| Project | IEEE 802.16 Broadband Wireless Access Working Group < http://ieee802.org/16 > | |
| Title | Changes on 802.16e Working Document for IP Address Allocation by Mobile IP | |
| Re: | This is a response to a Call for Comments IEEE 802.16e-03/18 on IEEE 802.16e-03/07r3 | |
| Abstract | This document contains suggestions on the changes in IEEE 802.16e-03/07r3 that would help IP address allocation in Mobile IP Registration procedure. | |

Table 62-b – Mobile IP Registration

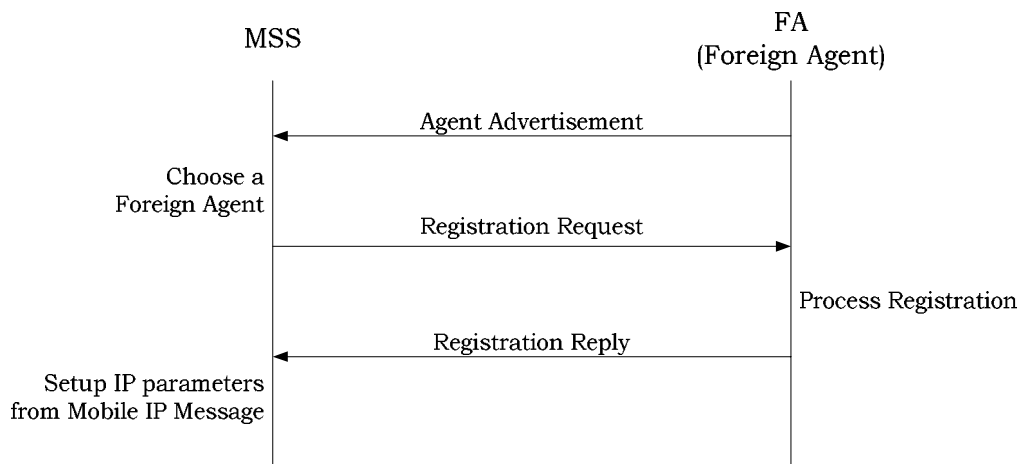
6.2.9.10.1 Establish IP Connectivity via Mobile IP Registration

At this point, the Foreign Agent (FA) shall invoke Agent Advertisement message, and then the MSS shall invoke Mobile IP registration [IETF RFC 3344] in order to obtain an IP address and any other parameters needed to establish IP connectivity. The Mobile IP registration response message shall contain the MSS’s IP address and a home agent address of the MSS and other configuration information. Establishment of IP connectivity shall be performed on the MSS’s Secondary Management Connection ; see Table 62-b
